## City Transport

### *Transport Development Management*

### *Application Response*

**To:** [REDACTED], Planning Team  
**From:** [REDACTED] Transport Development Management  
**Date:** 04 September 2025  
**Address:** Chasefield House 888 Fishponds Road Fishponds Bristol BS16 3XB  
**Application No:** 25/13176/PINS  
**Proposal:** Conversion of existing care home (C2) to provide 2x large Sui Generis HMOs (9x + 10x beds)  
**Response:** Initial  
**Recommendation:** Refuse

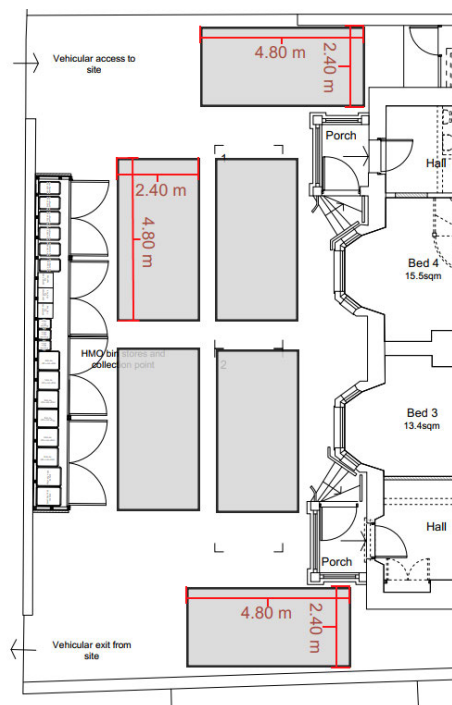
16. TDM argued in response to 22/02990/F that it was not possible to tell from the April 2022 parking survey whether there were sufficient parking spaces available on the South side of Fishponds Road/Staple Hill Road, i.e., without needing to cross a classified road, to meet the additional demand; however, the applicant's planning agent confirmed by email dated 26 June 2023, that:

If the parking survey in this case, with the 150m radius, is restricted to: (i) the spaces on the southern side of the highway (whereby no crossing over the A or B roads would be necessary); and (ii) wholly unrestricted spaces (i.e. discounting the spaces subject to daytime restrictions only); then based on the results of the survey, there would only be 1 available space on the first day of the survey and 2 available spaces on the second day. In
